## **COMMENT AND RESPONSE ON December 2006 IOP FSEIS**

Subj: Final Supplementary Environmental Impact Statement (FSEIS) on the Interim  
Operational Plan (IOP) for Protection of the Cape Sable Seaside Sparrow

Figure 1. WCA-3A Stages at Site 65 and the 3-Station Average

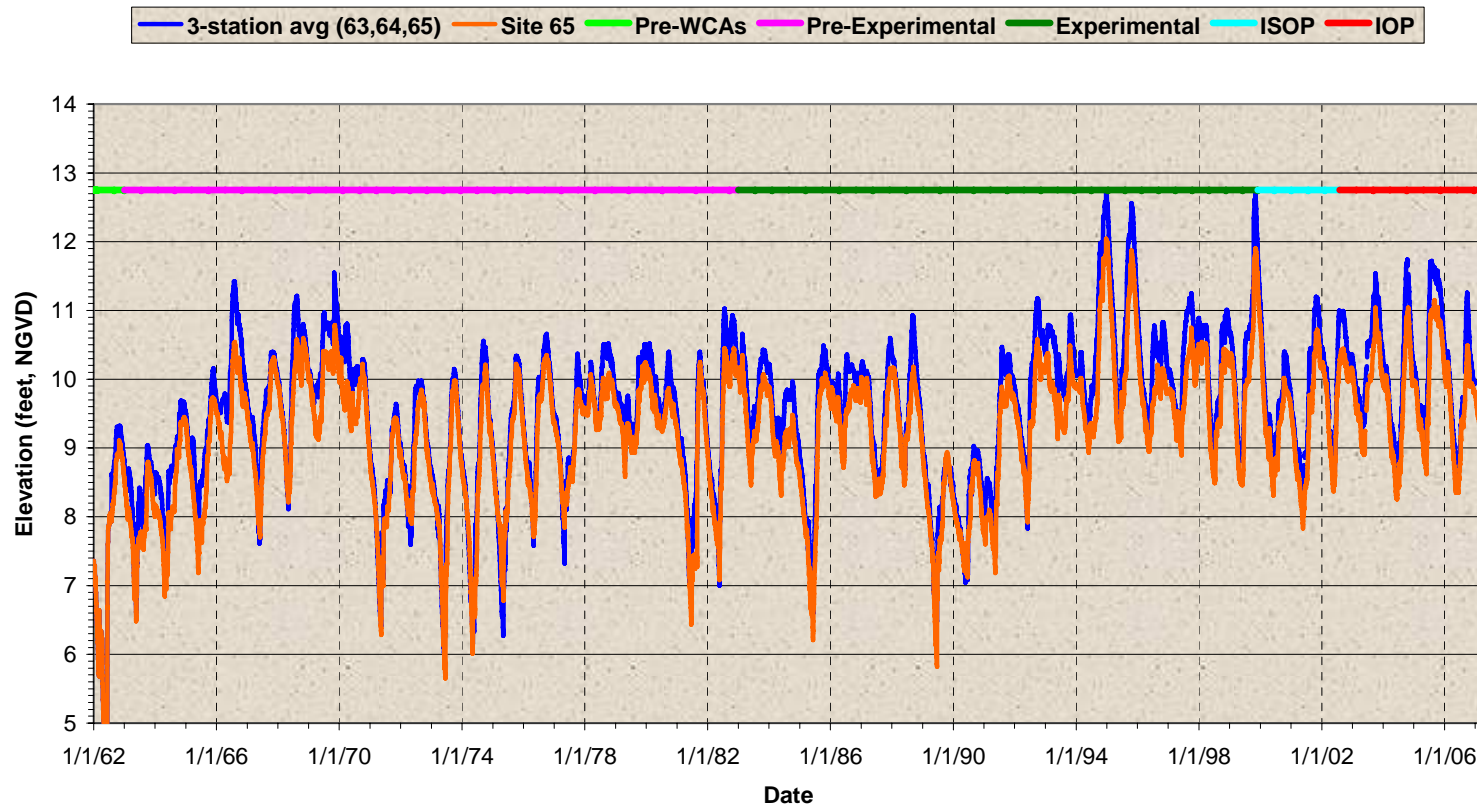
The Army Corps of Engineers (Corps) Final Supplemental Environmental Impact Statement (FSEIS) on the Interim Operational Plan (IOP), even while legally inadequate, contains proof that the "experiment in the field" that the Corps and the Fish and Wildlife Service ("FWS") have conducted in the Everglades for the past nine years has destroyed vast areas of the Tribe's Everglades homeland and is threatening the continued existence of the endangered Snail Kite. Despite being forced by a Federal Judge to conduct an SEIS, the Corps continues to refuse to conduct the environmental analysis required by law, including the mandatory cumulative impacts analysis of IOP when added to other actions. This failure has likely caused the Corps to even underestimate the harm it is causing to vast areas of the Everglades that it has been charged by Congress to restore under the Comprehensive Everglades Restoration Plan "CERP." **MIT-1**

*This information is graphically illustrated in Figure 1. The FSEIS further acknowledges on page 79:*

*Figure 1 illustrates the actual observed water levels in WCA-3A from available recorded water level data. The graph depicts the 3-station average water levels observed at Sites 63, 64 and 65 and the water levels observed at the southern most gage in WCA-3, Site 65. The colored bar across the top of the graph denotes the various operational regimes over time. The observed historical water level data shows that the three highest stages recorded in WCA-3 occurred in the 1994-1995, and 1999 wet season during the period of operations associated with Test 7 of the Experimental Program. As depicted in Figure 2, the third highest water level in WCA-3 was associated with Hurricane Irene which passed over the area October 14-16, 1999. The operations associated with Test 7 of the experimental program officially terminated in January, 2000. Transition to ISOP operations occurred in December 1999. Water levels in WCA-3 had reached 12.62 feet by October 31, 1999 under Test 7 operations and peaked on November 3, 1999 at 12.69 feet prior to the transition to ISOP operations. Therefore, two of the three highest recorded water levels in WCA-3 occurred prior to any closures of the S-12s to protect the sparrow and the third highest water level in WCA-3A had reached 12.62 feet prior to transition of operations to ISOP, after which time the water level increased by an additional 0.07 feet. The observed water level data reflect the sensitivity of the water management system to rainfall and climatic events. There is considerable evidence that a large scale shift in climate patterns may be partially responsible for higher stages in WCA-3A during the past 15 years.*

Figure 3. Number of Weeks above 10.5 feet NGVD in WCA-3A at Site 65 and 3-Station Average.

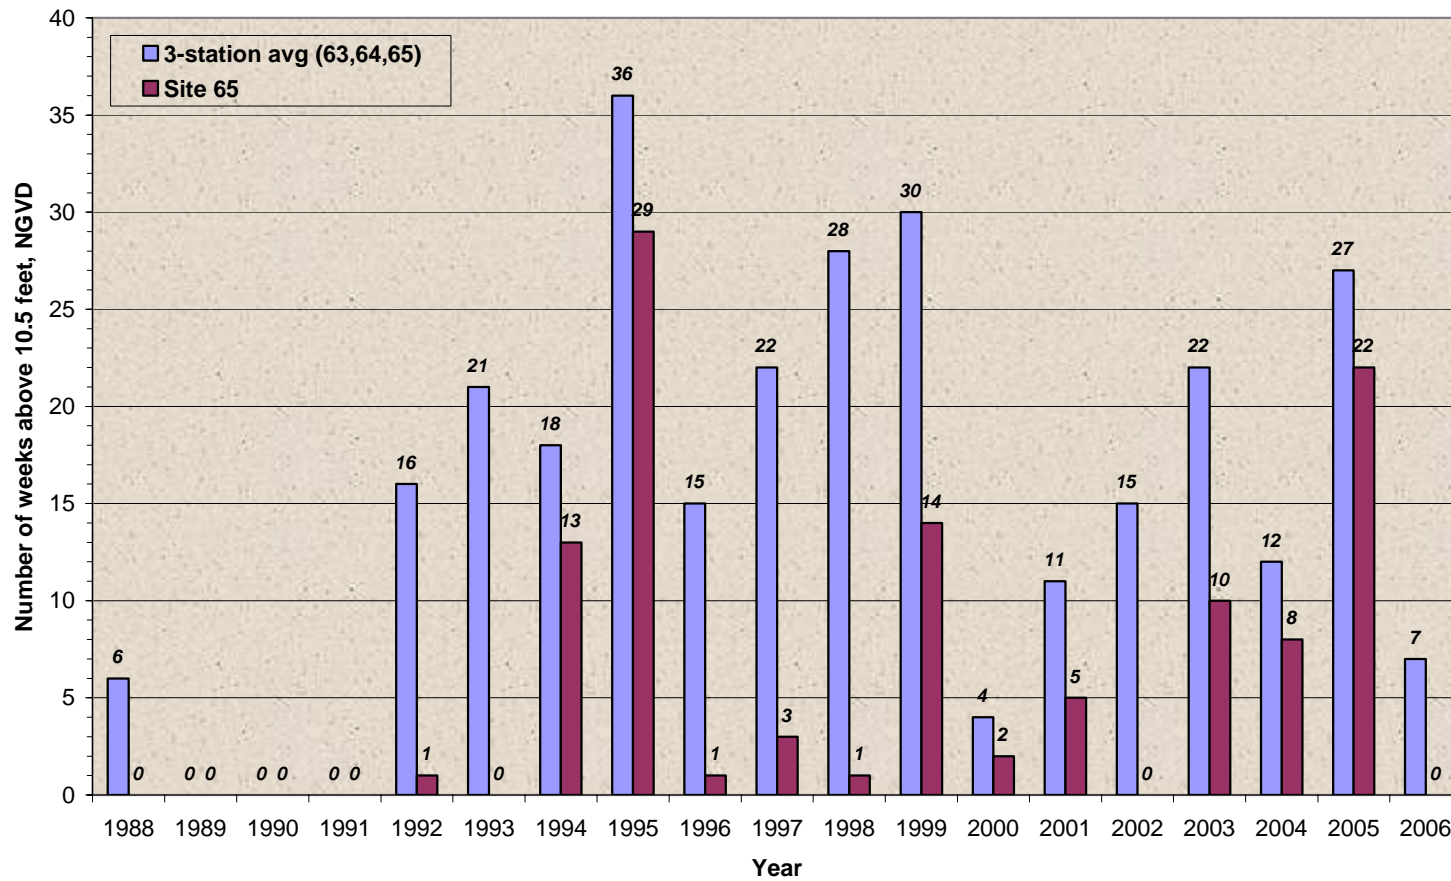
allegedly taken in response to the demands of the FWS, has caused, and will continue to cause, irreversible destruction of Tribal Everglades in WCA 3A, and has adversely affected the Snail Kite and its critical habitat there. FSEIS at 75-80; Attachment A-1, A-2 and A-3. The document admits: "The principal concern is that the habitat quality, and thus the carrying capacity of, WCA 3A is already seriously degraded." FSEIS at 79. "Habitat quality in WCA 3A is changing progressively and dramatically to less desirable habitat in this area, and this conversion is rapid, with changes even after a year." Id. at 79. "The snail kite population in Florida progressively and dramatically decreased between 1999 and 2002." Id. at 77. "Since 2002, kite production in WCA 3A has dramatically dropped, having produced no kites in 2005." Id. Most alarming, Dr. Wiley Kitchens believes that "this trend of lowered reproduction is a cause of concern regarding the sustainability of the population." Id. The Tribe warned that modeling showed that IOP 7R would exacerbate the flooding in WCA-3A, but neither the Corps nor FWS cared about the Tribe's Everglades, nor the plight of the Snail Kite.

*Figure 3 graphically illustrates the number of weeks the actual observed 3-station average of water levels in WCA-3A and water levels at site 65 gage exceeded 10.5 feet from 1988 to present. After the very dry period from 1988 to 1991, many years have been above the 10.5 stage at Site 65. During the period from 1992 to 1999, when there were no S-12 spring closures for sparrow deviations to the Experimental Program, 7 out of the 8 years exceeded 10.5 ft. Closure of the S-12 in December of 1999 was the result of the high water created by Hurricane Irene, not spring closures of the S-12s. During the period from 2000 to 2006, when S-12 spring closures have occurred, 5 out of 7 years have had stages above 10.5 ft at Site 65. This information, combined with the MIT-1 response (about Figures 1 and 2), indicate that there is no apparent trend indicating the S-12 spring closures have induced higher stages in southern WCA-3A.*

**Figure 4 Site 65 Historical Data and 5-Year Rolling Average**

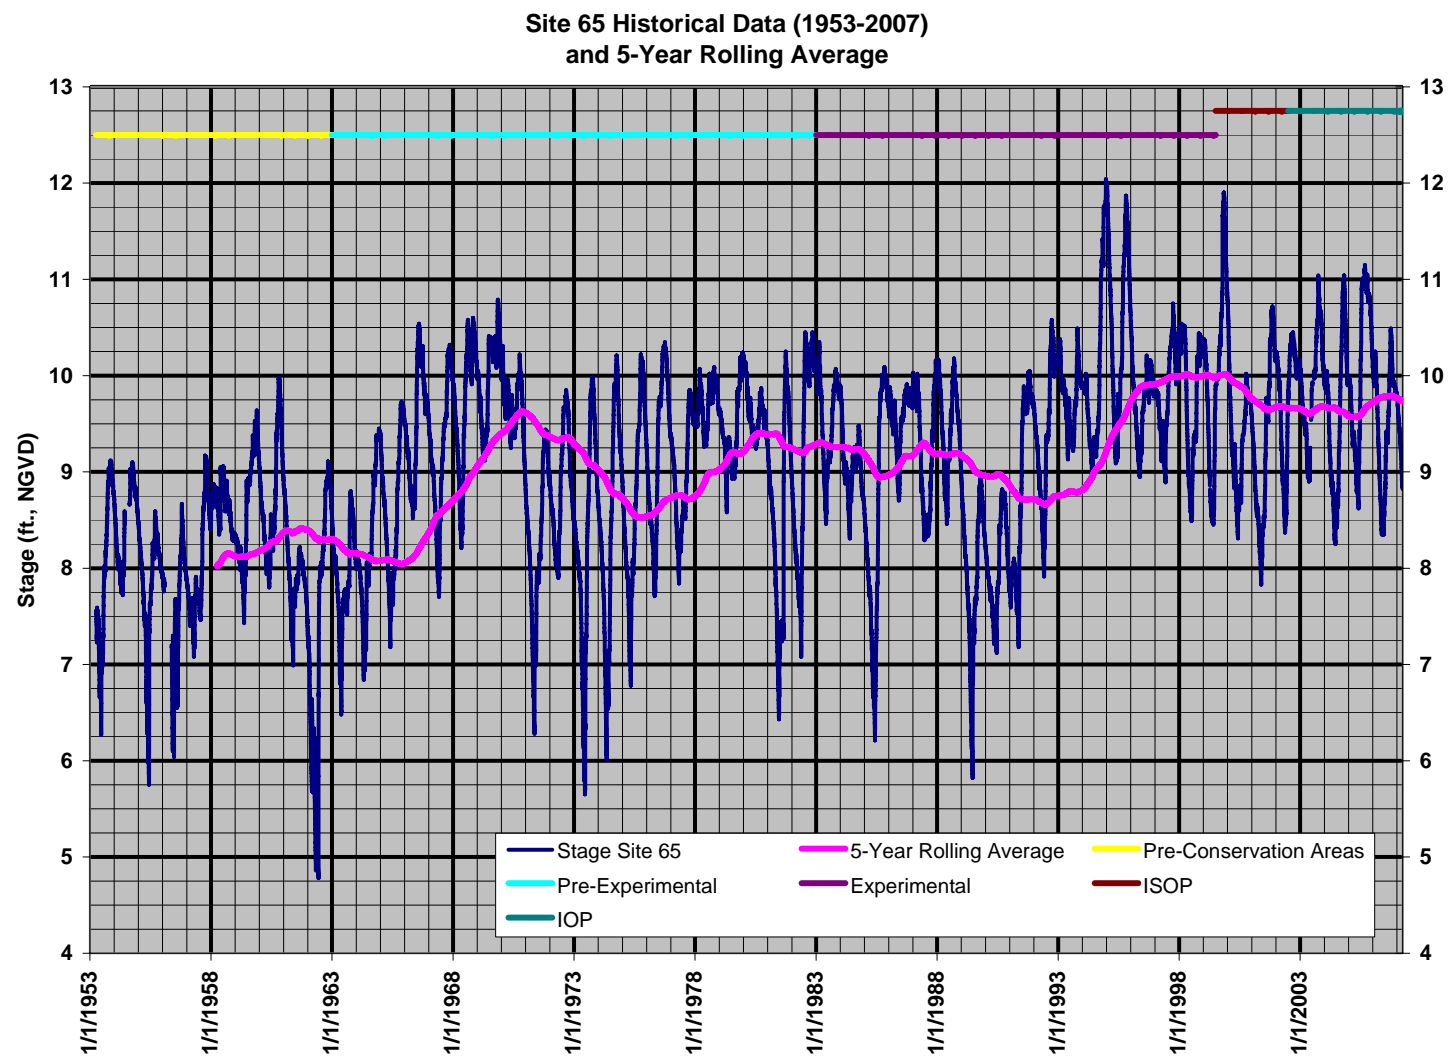
While certain figures attached to the appendix in the FSEIS show average water elevation from 2002 to the present, they fail to compare this to the period of record and should do so. A review of the text shows that despite the Corps' past arguments that ISOP and IOP have not increased water levels in WCA 3A, the high water stages have decreased dramatically. The document admits that "stages in WCA 3A have exceeded 10.5 feet (3.2 m.) in 10 of the past 13 years, while there were only about 4 occurrences of stages exceeding 10.5 ft. (3.2 m.) during the 40-year period from 1953-1993." *Id.* at 76. However, the data to support these statements is not included in the FSEIS and should be, because NEPA is required to be a full disclosure document. It is improper under NEPA to not divulge these modeling results to the public.

***Figure 4 shows the historical data for Site 65 as well as the computed five-year average. This figure shows that prior to impoundment of the Water Conservation Areas, based on a short***
